# UNITED STATES PATENT AND TRADEMARK OFFICE

APPLICATION NO.	FILING DATE	FIRST NAMED INVENTOR	ATTORNEY DOCKET NO.	CONFIRMATION NO.
10/724,667	12/01/2003	Lee J. Brown	1614	2407
20676	7590	11/22/2005	EXAMINER	
ALFRED J MANGELS 4729 CORNELL ROAD CINCINNATI, OH 452412433			YIP, WINNIE S	
			ART UNIT	PAPER NUMBER
			3636

# Office Action Summary

## DETAILED ACTION

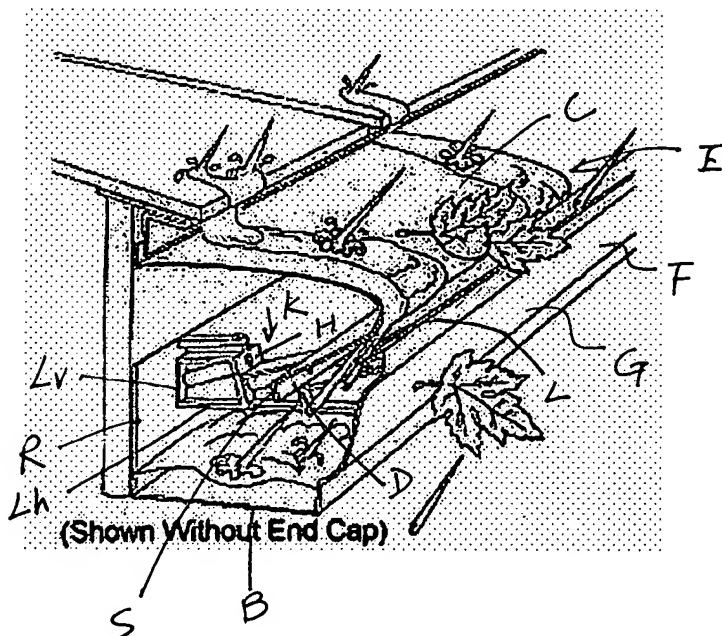
14. Claims 1-18 are rejected under 35 U.S.C. 103(a) as being unpatentable over Solution Company, Inc. (1/03) in view of Knudson '435.

Solution Company, Inc. shows and teaches a rain gutter assembly comprising: **(a)** an elongated gutter (G) having substantially U-shaped channel including a rear wall (R), a bottom wall (B) and a front wall (F), the front wall including an inwardly-extending lip (L) at an uppermost edge of the front wall, the lip having a reentrant flange extending backward and toward the front wall; **(b)** at least two support brackets (K) positioned and engaging between the front wall and the rear wall of the gutter, the bracket having a substantial L-shape body including a first vertical leg (Lv) having a mounting surface to contact the rear wall the of gutter and having a least one first bore (H) forming at least one passageway for receiving a connector which is a bracket fastener (3" screw) to provide a support means for securing the bracket and the gutter to the rear wall to the roof building surface, the support means having a surface inclined in a downward direction, and a substantially horizontal leg (Lh) positioned between the

rear and front walls of the gutter, the horizontal leg (Lh) having support surface having at least one second bore for receiving a fastener for securing the front edge of the gutter cover and a stepped portion (I) below the second bore providing a stop surface for abutment with and positioning relative to the bracket of the front edge of the cover, and the bracket having a front end providing an engagement means to engage and support the reentrant flange of the gutter front wall in a vertical direction; and (c) a cover having a plate-like cover body (C) overlying and spaced above the gutter opening, an inturned front wall (E) defining a curved front surface and terminate at a front edge of the cover body and lies between the gutter front wall and the gutter rear wall, and the front edge of the cover body having an inwardly-facing surface (D) being engaged and secured by a support surface (S) of the brackets, and the front surface of the cover body being spaced from the gutter front wall to define a gap about  $\frac{1}{2}$  inches therebetween to allow water flow into the U-shaped channel of the gutter. The Solution Company, Inc. does not show the rain gutter assembly including a gutter having a rear wall having a vertical height greater than that of the front wall such that the rear wall of the cover having a contact surface contacting the rear wall of the gutter and securing the rear walls of the gutter and the cover to the building surface as claimed, and the vertical leg does not carry a support means for engaging and supporting a rear portion of the cover. Knudson teaches a rain gutter assembly (12 or 92) comprising a U-shaped gutter (16 or 96) having a front wall (17 or 97) terminated at an inwardly upward front edge for engaging with the front brackets by fasteners (13) and having a rear wall (2) extending substantial vertical along the rear edge of the gutter to define a contact surface for abutting a substantially vertical building surface, wherein the rear wall (18 or 98) of the gutter may extend upward in a height greater than the height of the front wall of the gutter, a cover
